Kodak DryView

8300/8600/8610 LASER IMAGING SYSTEMS

Service Bulletins

SERVICE BULLETIN NO. 884

Procedure to Reduce Film Errors (EC33)

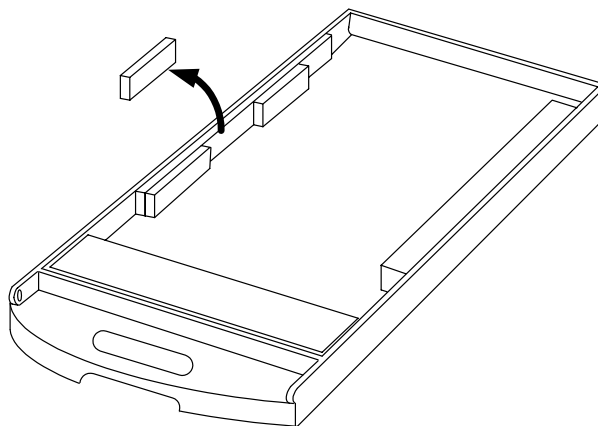
Excessive pressure applied to the film by the registration foam, on the left side of the FILM TRAY, can cause film-feed retries and failures. The easiest way to reduce this pressure is to remove the middle third of the six-inch foam that holds the film in place.

With a ruler and a sharp knife, measure, cut and remove the middle two inches of the registration foam as shown in the illustration. Be sure to remove only the middle two inches of foam. Clear the FILM TRAY of all foam debris resulting from the cuts.

Figure 1

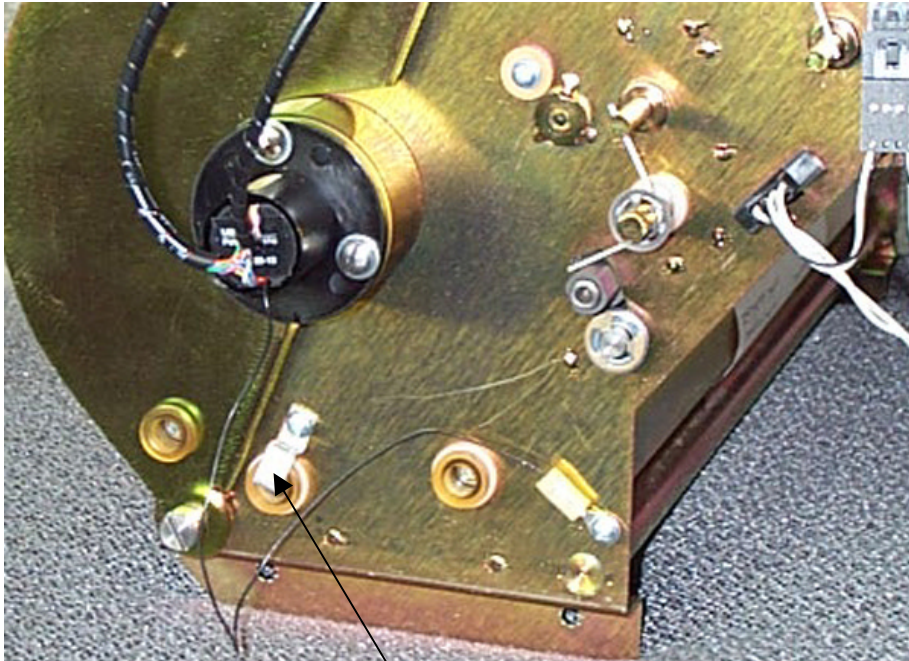
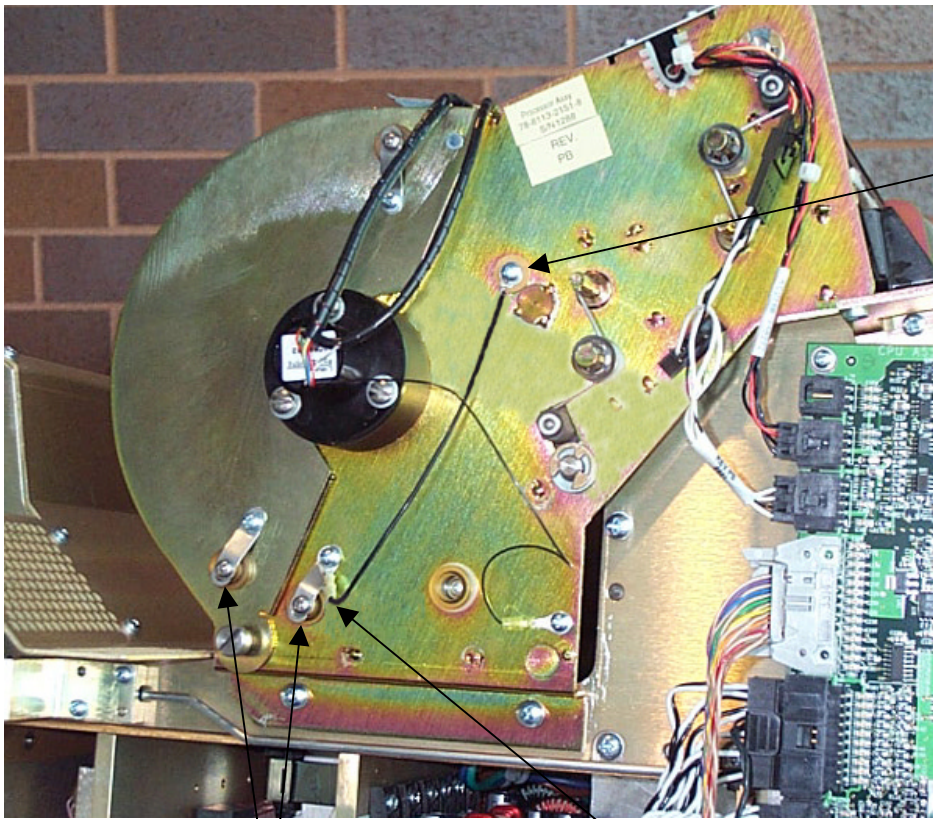
The purpose of this service bulletin is to provide instructions for grounding the PROCESSOR ASSEMBLY using the PROCESSOR GROUNDING HARDWARE KIT, 8E2003.

1. Remove the SPRING CLIPS from the FRAME and CLAMSHELL of the PROCESSOR ASSEMBLY (see Fig. 1).
2. Attach one end of the WIRE (supplied in the KIT) to the STRIPPER ASSEMBLY using the right mounting SCREW of the STRIPPER ASSEMBLY (see Fig. 2).
3. Attach one end of 1 small STRAP (supplied in the KIT) along with the loose end of the WIRE referred to in Step 2, to the FRAME where the CLIP was removed in Step 1 (see Fig. 2).
4. Remove the SCREW holding the ROLLER ASSEMBLY MOUNTING ROD, and using the supplied SPACER and SCREW, attach the loose end of the small STRAP to the ROLLER ASSEMBLY MOUNTING ROD (see Fig. 2).
5. Repeat Steps 3 and 4 to attach the remaining small STRAP to either side of the CLAMSHELL portion of the PROCESSOR ASSEMBLY.

19-01/02 ROLLER BEARING KIT for STRIPPER ASSEMBLY

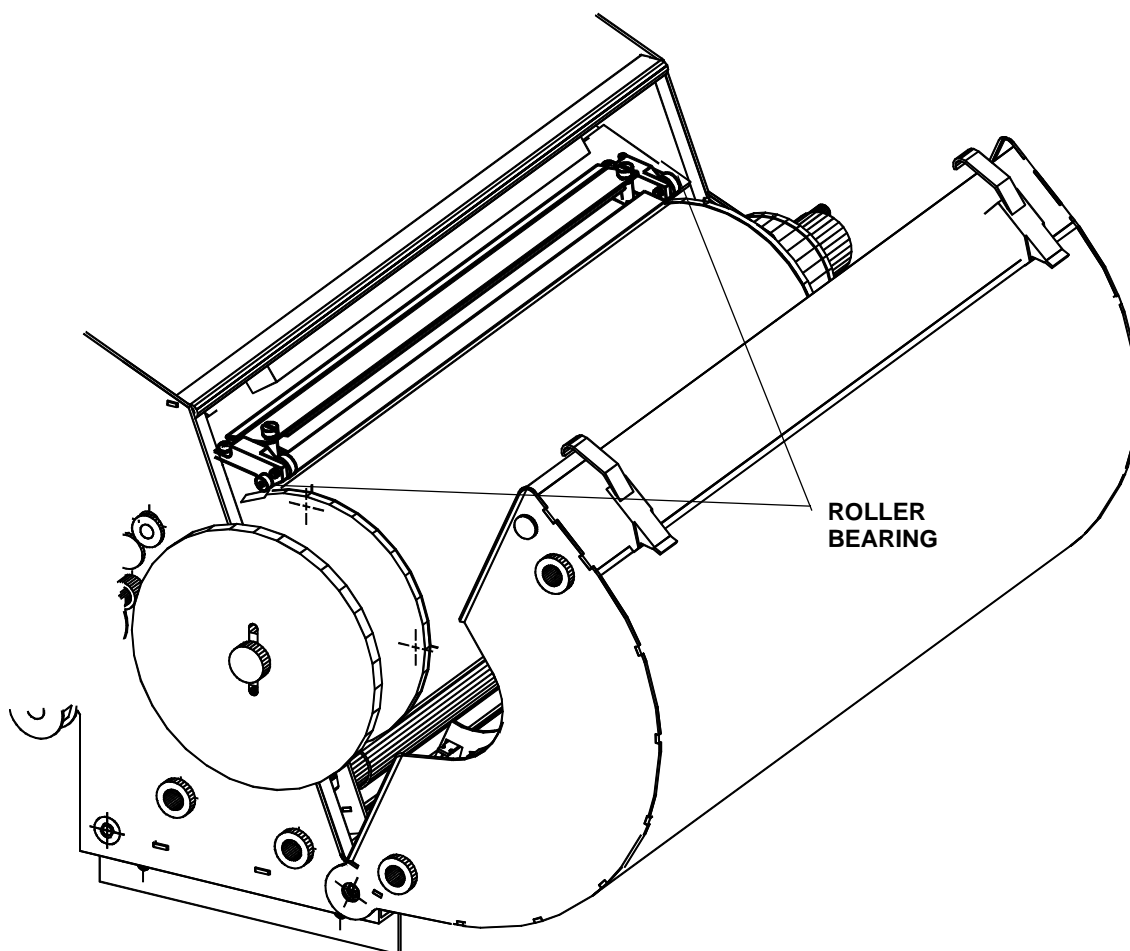
A new ROLLER BEARING KIT 8E2026 can now be ordered from Service Parts Management instead of installing a new STRIPPER ASSEMBLY.

Figure 3. Comparison of 8300 and 8600 Capstan Pulley Drive Configurations

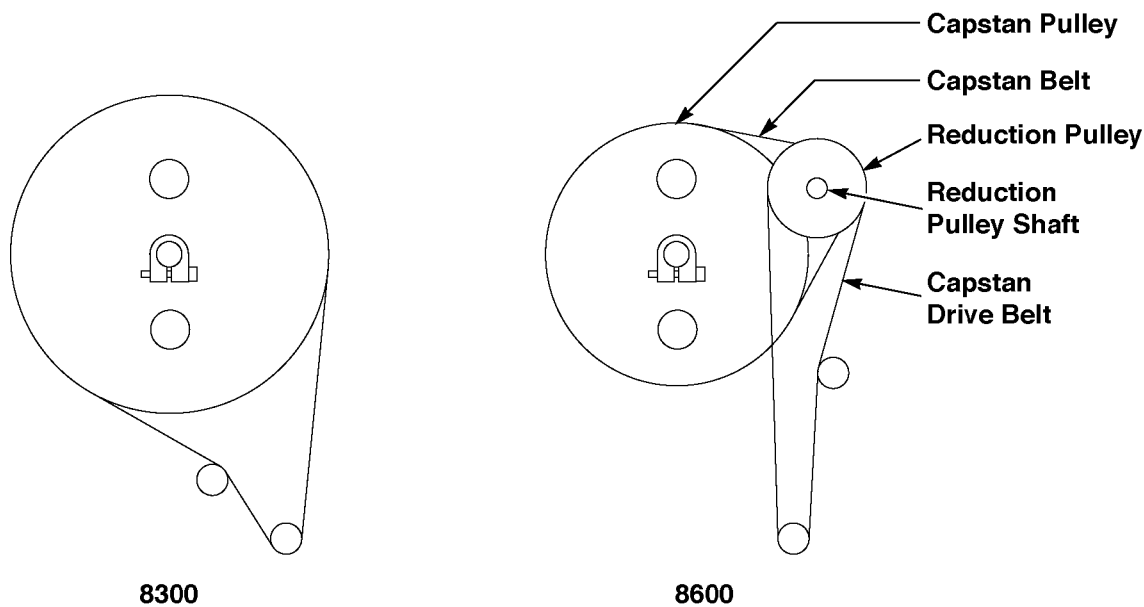
Capstan Drive Belt – Different size because it is used to transfer drive from the capstan motor to a reduction pulley. In the 8300 the capstan pulley was driven directly from the capstan motor. (See Figure 3.)

Capstan Reduction Pulley – New part to reduce the speed of the capstan roller. (See Figure 3.)

Reduction Pulley Shaft – New part to hold the Capstan Reduction Pulley. (See Figure 3.)

Capstan Belt – New part to transfer drive from the reduction pulley to the capstan pulley. (See Figure 3.)

Capstan Pulley – Different size because used in conjunction with the reduction pulley. (See Figure 3.)

26-01/02 ROLLER BEARING KIT for STRIPPER ASSEMBLY

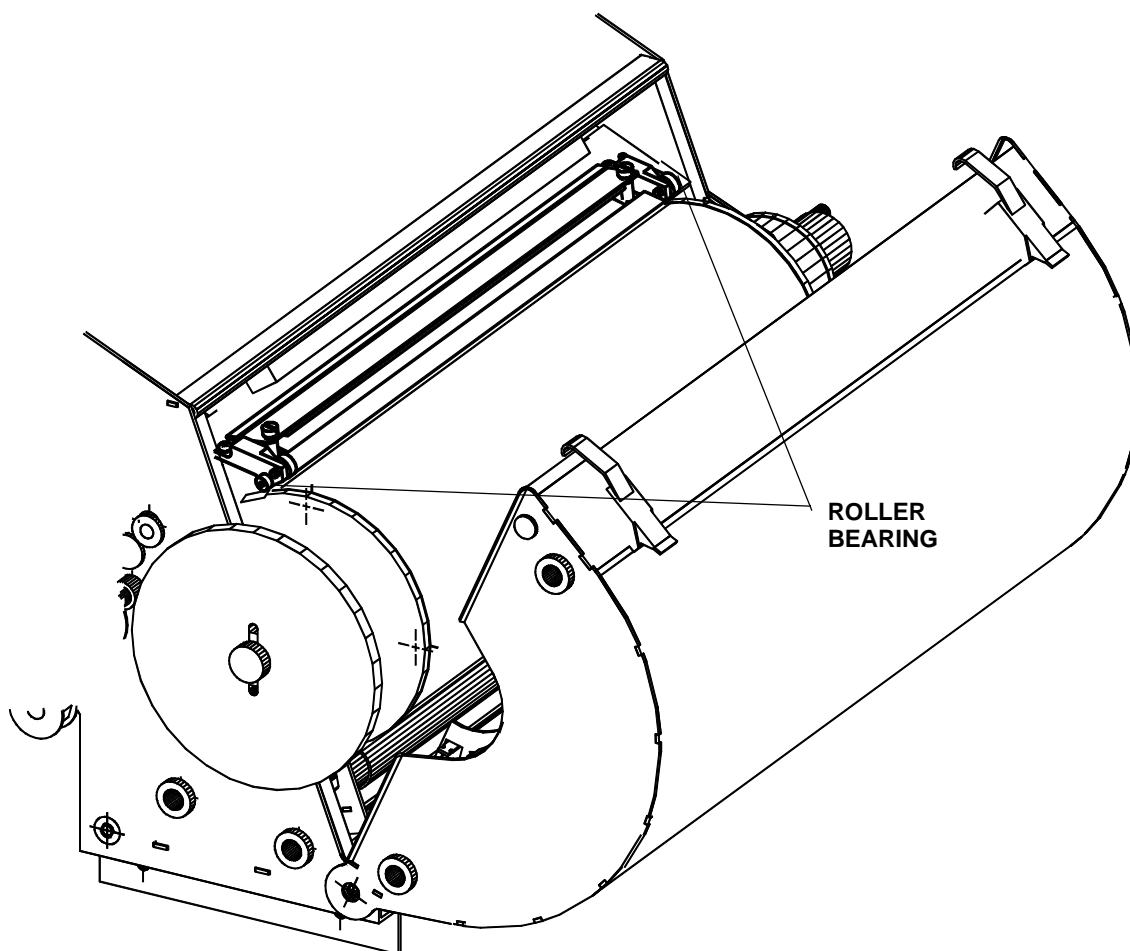
A new ROLLER BEARING KIT 8E2026 can now be ordered from Service Parts Management instead of installing a new STRIPPER ASSEMBLY.

Figure 1

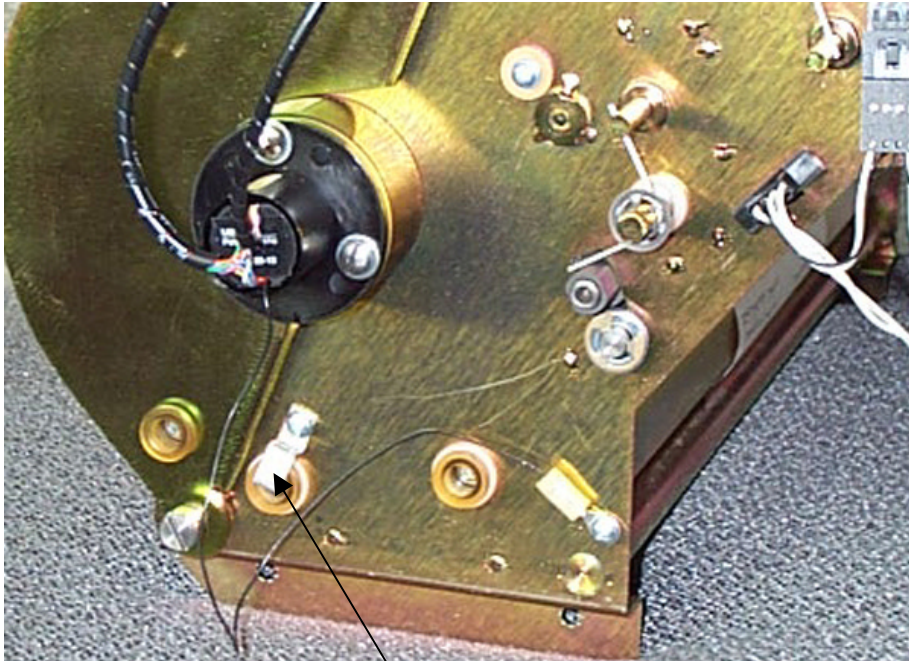
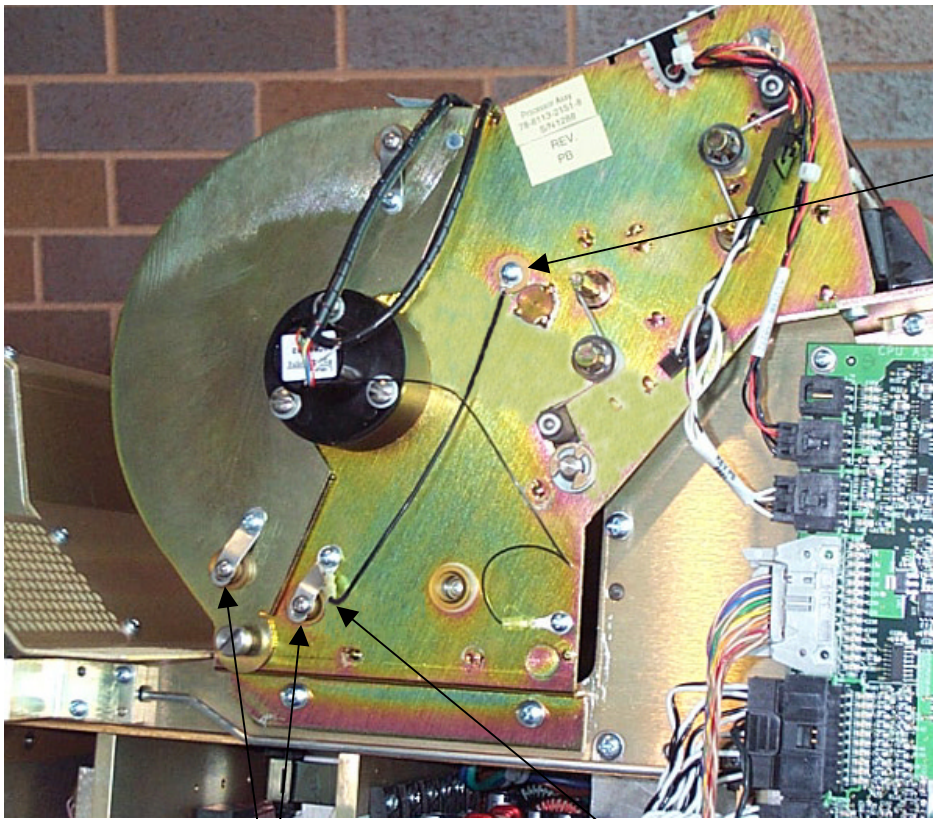
The purpose of this service bulletin is to provide instructions for grounding the PROCESSOR ASSEMBLY using the PROCESSOR GROUNDING HARDWARE KIT, 8E2003.

1. Remove the SPRING CLIPS from the FRAME and CLAMSHELL of the PROCESSOR ASSEMBLY (see Fig. 1).
2. Attach one end of the WIRE (supplied in the KIT) to the STRIPPER ASSEMBLY using the right mounting SCREW of the STRIPPER ASSEMBLY (see Fig. 2).
3. Attach one end of 1 small STRAP (supplied in the KIT) along with the loose end of the WIRE referred to in Step 2, to the FRAME where the CLIP was removed in Step 1 (see Fig. 2).
4. Remove the SCREW holding the ROLLER ASSEMBLY MOUNTING ROD, and using the supplied SPACER and SCREW, attach the loose end of the small STRAP to the ROLLER ASSEMBLY MOUNTING ROD (see Fig. 2).
5. Repeat Steps 3 and 4 to attach the remaining small STRAP to either side of the CLAMSHELL portion of the PROCESSOR ASSEMBLY.

Procedure to Reduce Film Errors (EC33)

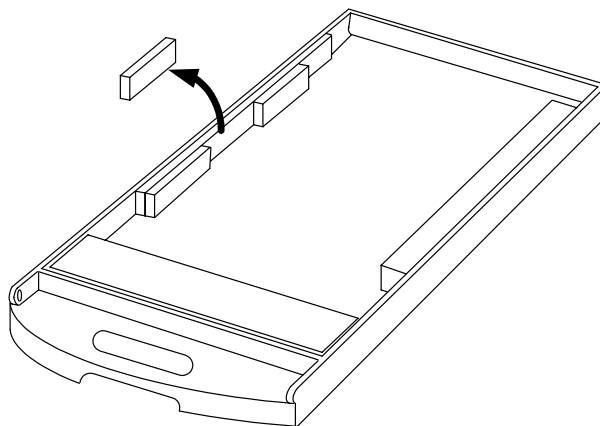
The purpose of this Service Bulletin is to communicate that there is a relatively easy way to reduce the number of film-feed retries and failures that result in EC 33. On your next service call, examine the Error Log, which can be accessed from the Test Menu (911). If there are EC 33s listed in the log, perform the procedure below.
